THIS IS A COMPUTER GENERATED DRAWING DO NOT REVERSE		Exelon Nuclear	
302-356		STATION BLACKOUT DIESEL FLOW DIAGRAM	
302-356		GENERATOR INSTRUMENT AND STARTING AIR SYSTEM FOR EG-Y-4	
302-356		302-356	
302-356		N/A

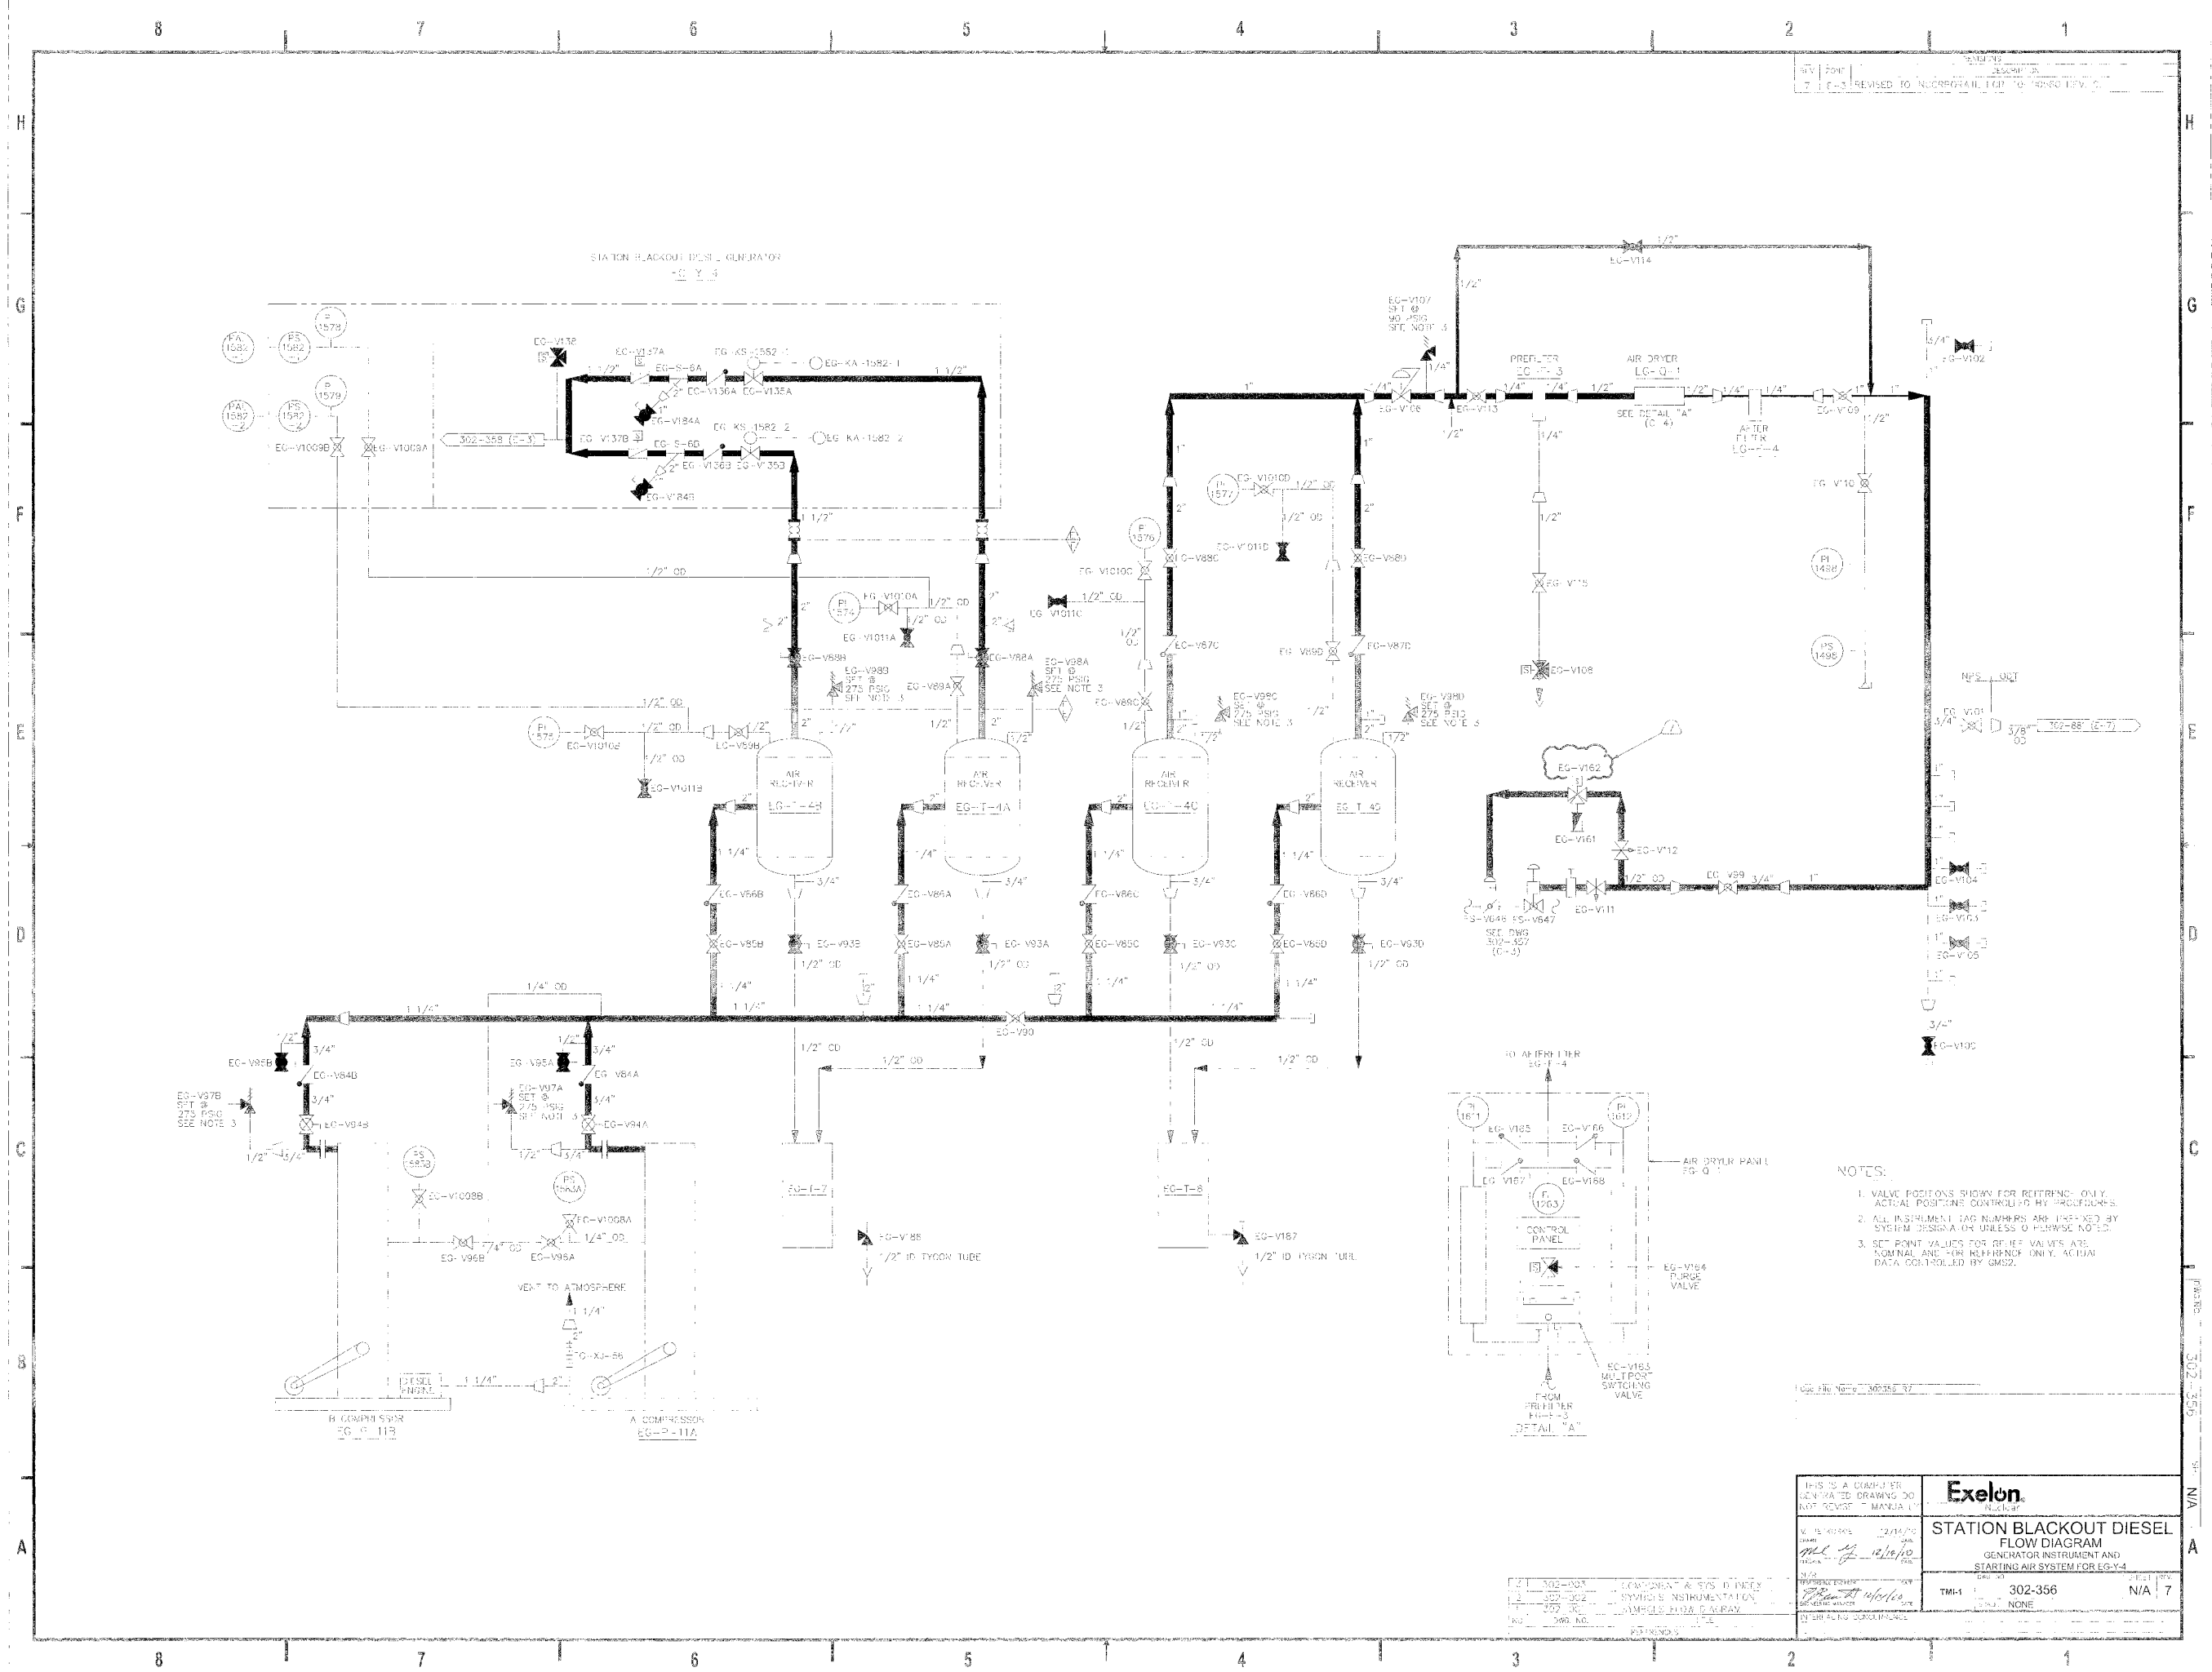
302-356
REVISED TO INCREASE FLOW TO 1000 GPM
